No. **97-1**

**SUBJECT: Needle Bearing Replacement**

No. **97-2**

**SUBJECT: Carburetor Flange Clamps**

1. Needle bearing
2. Circlip

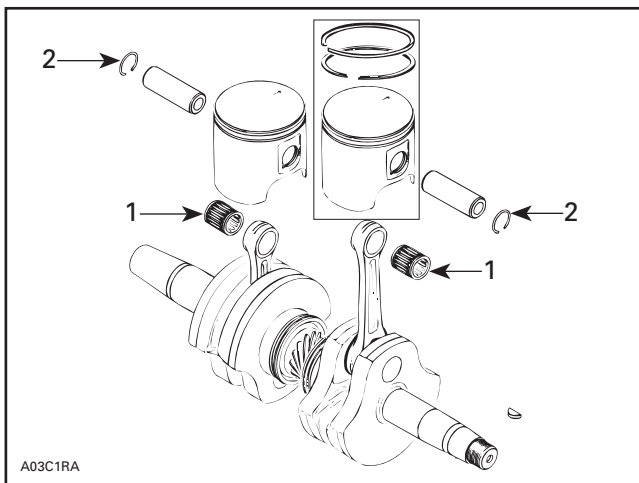
Improper heat-treatment applied to piston needle bearings.

Replace existing needle bearings with new ones.

1. Existing clamp
2. New clamp

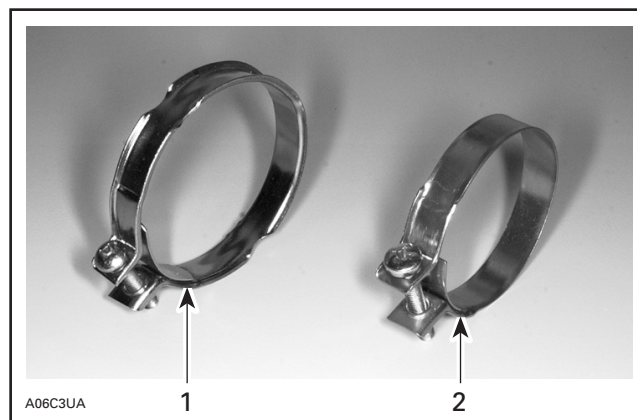
The clamps retaining carburetors to the rubber flanges may slide out of place when tightening. This situation may lead to air leak and engine failure.

Replace existing clamps with new ones.

- Remove air intake silencer assembly.
- Loosen clamps retaining carburetors to flange and slide carburetors out of flanges.
- Remove clamps from carburetor flanges and replace with new ones.
- Reinstall carburetors in rubber flanges.
- Tighten new clamps to secure carburetors.
- Torque to 0.5 N•m to 0.8 N•m (4.5 lbf•in to 7.3 lbf•in).
- Reinstall air intake silencer assembly.

1. Double air silencer assembly

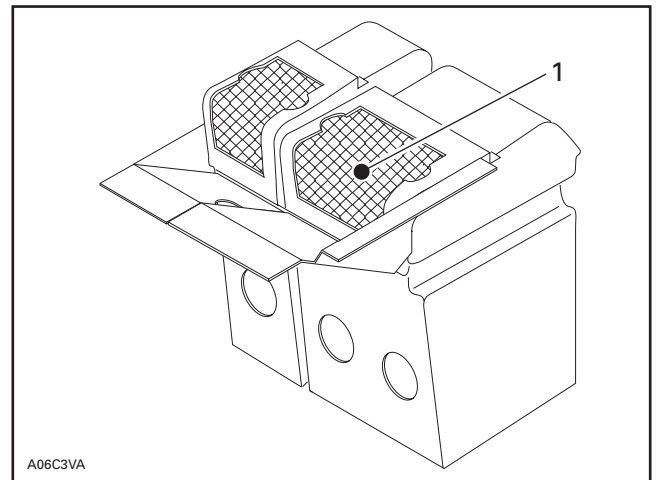
The foam used for the air filter which is located on top of the double air silencer assembly has too low of density.

Replace existing air filter with new part that has higher density foam.

1. Washer must be here

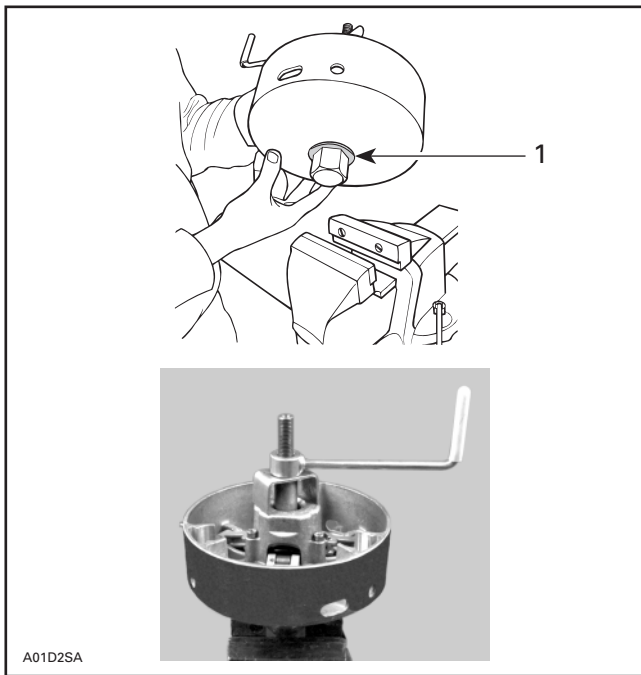
The 3 Allen screws retaining the spring cover on the sliding half of the drive pulley may be insufficiently torqued.

Re-torque the 3 Allen screws to 13 N•m (9.5 lbf•ft).

If threads on the sliding half have become damaged, replace the sliding half with new part.

1. Modify this tab (one on each side)

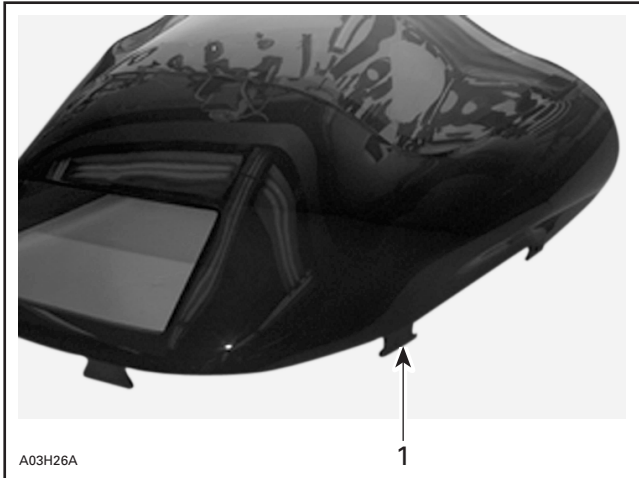
Windshield may become loose due to rubber straps sliding off of the 2 tabs that are located on the sides nearest to the front on windshield base.

Modify the 2 tabs located on the sides, nearest to the front as shown on the following photo.

1. Before
2. Existing shape
3. After
4. Modify to look like this
- A. 19 mm (3/4 in)

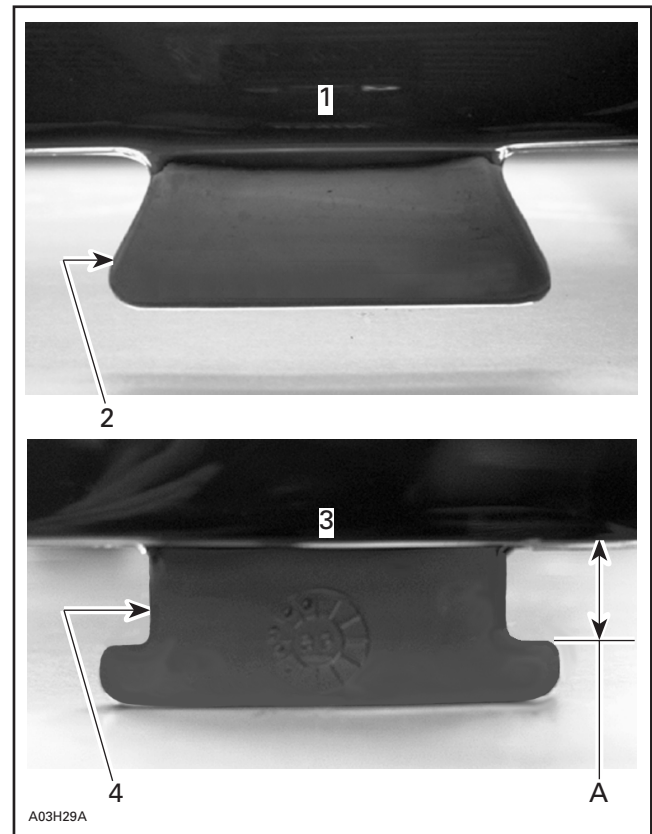
Modify tabs using a file or cutters as indicated in the following photo.

1. Actual cam pulley angles (44/40)
2. New cam pulley angles (40/44)

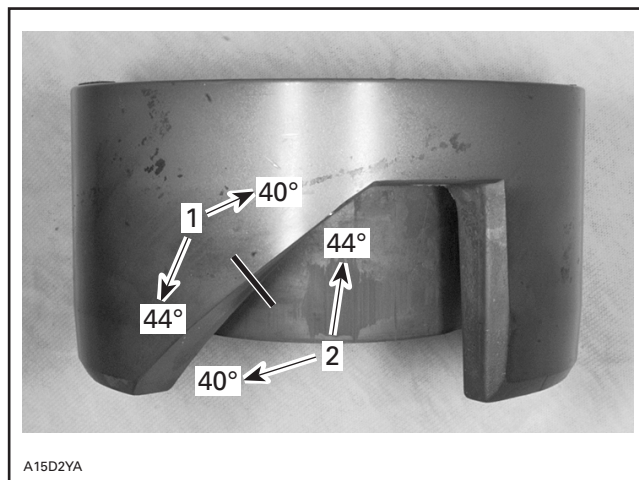
On the above mentioned snowmobiles, the driven pulley cam has incorrect cam angles. This results in poor performance at low revolution and over revving at mid range.

Replace driven pulley cam with new one. In order to obtain optimum engine performance, the new cam angles match the stock pulley calibration from factory.

1. Protective plate
2. Insulator
3. Rivets (3)
4. Washers (3)

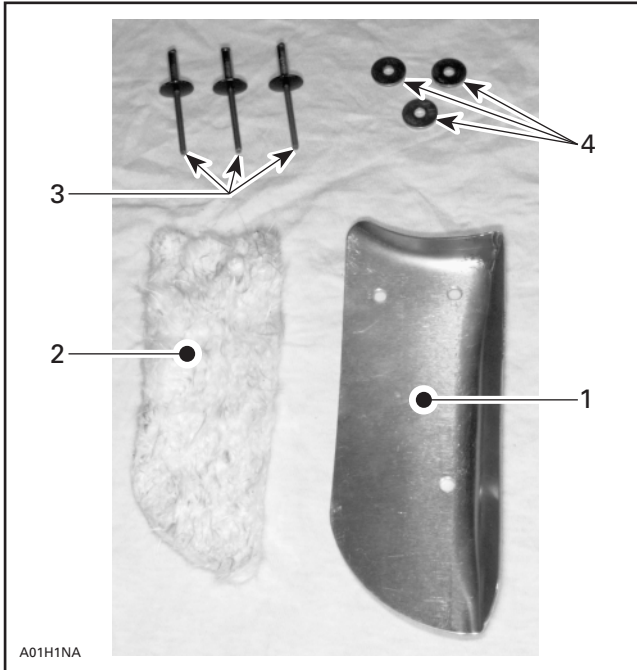
Bottom pan material may be damaged by high temperature exhaust gas at exhaust outlet location, beside right hand swing arm attachment.

Install an insulator pad and a protective plate, then secure with rivets.

1. Needle bearing
2. Circlip

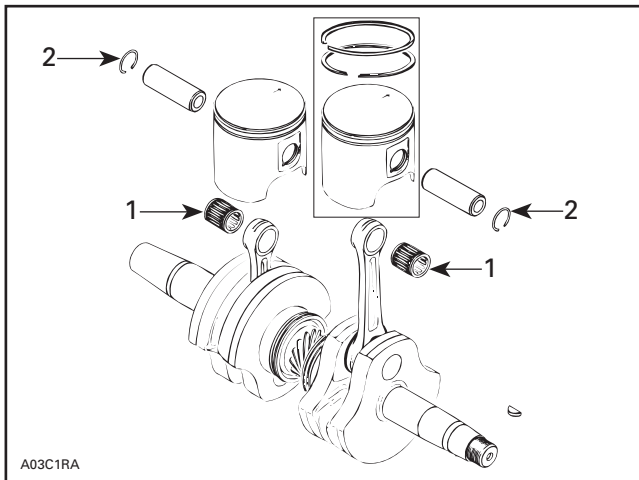
Improper heat-treatment applied to piston needle bearings.

Replace existing needle bearings with new ones.
